Entergy Nuclear Operations, Inc.
Pilgrim Nuclear Power Station
600 Rocky Hill Road
Plymouth, MA 02360

Proposed Change to Pilgrim's Technical Specification Concerning
the Safety Limit Minimum Critical Power Ratio (TAC # ME0241)

LETTER NUMBER: 2.09.006

PILGRIM RESPONSE TO REQUEST FOR ADDITIONAL INFORMATION (RAI)
RELATED TO CYCLE 18 SLMCPR TECHNICAL SPECIFICATION (TS) CHANGE FOR
PILGRIM NUCLEAR POWER STATION (PILGRIM)
(TAC # ME0241)

FIGURE 2
PILGRIM POWER / FLOW MAP
 Scram and Rod Block Data based on Nominal Trip Setpoints
 CORE FLOW, MLB/HR

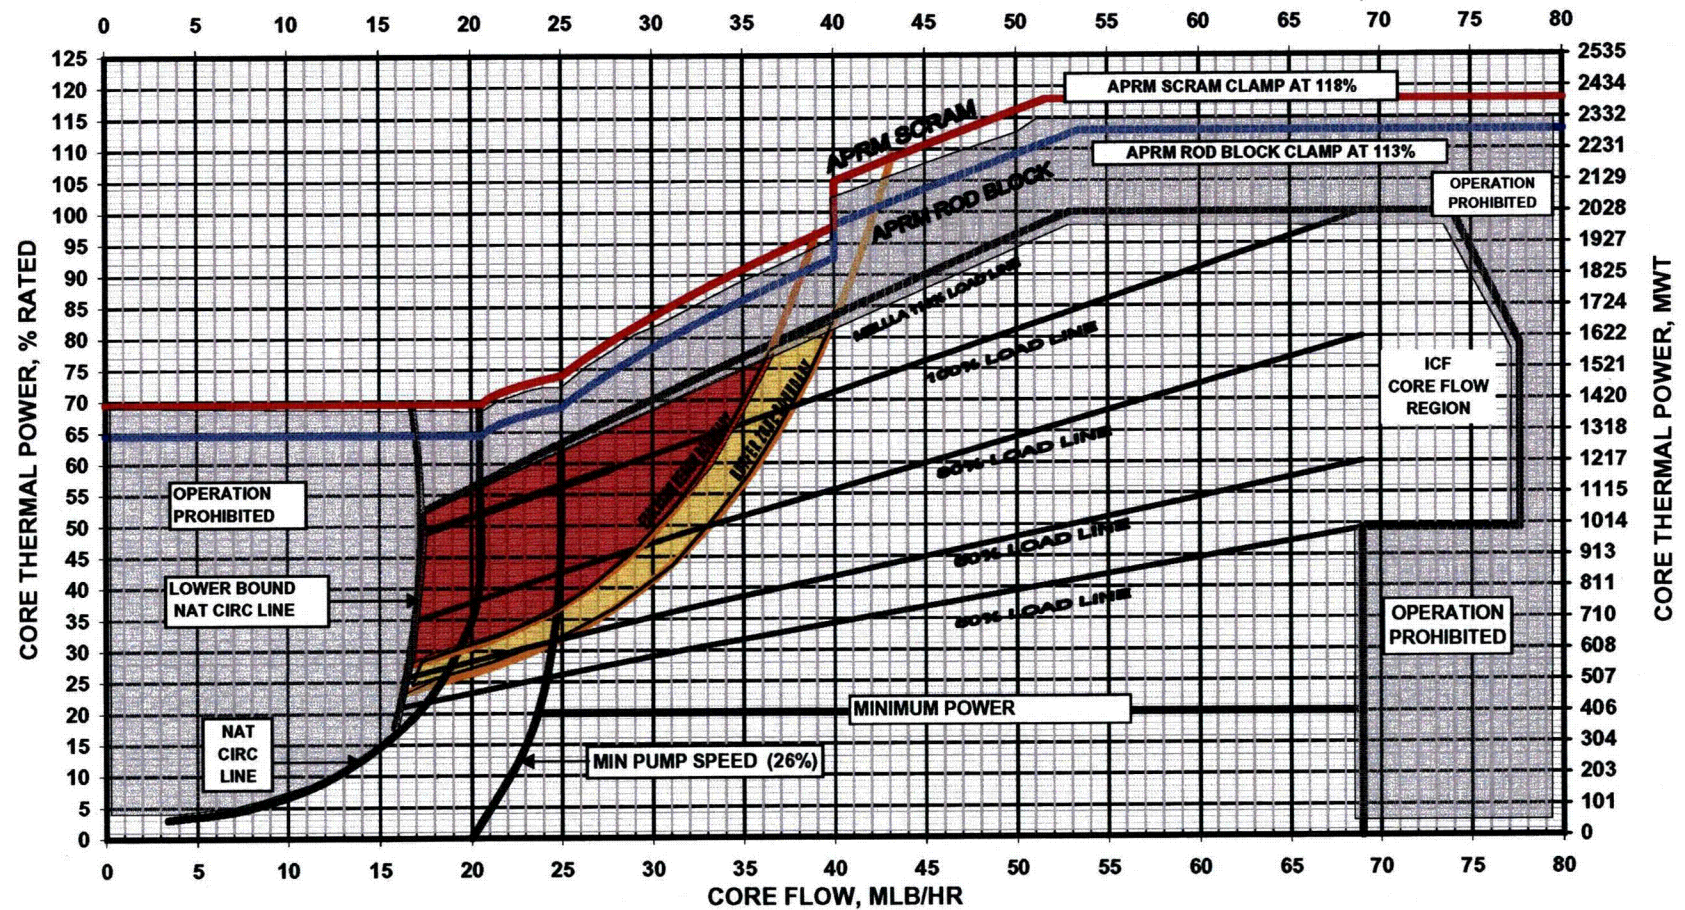
Provide the currently approved Power/Flow map for Pilgrim. If Pilgrim was authorized to operate in the Maximum Extended Load Line Limit Analysis (MELLLA) domain, please indicate for how long the plant has been operating with MELLLA.

Pilgrim Power-Flow Maps for Cycle 17 for Two Loop (Figure 2) and Single Loop (Figure 4) Operations are enclosed. PNPS has had MELLLA beginning with Cycle 11, which began on 6/7/1995. The MELLLA Analysis report is NEDC-32306P dated March 1994. MELLLA was implemented using 10 CFR 50.59.
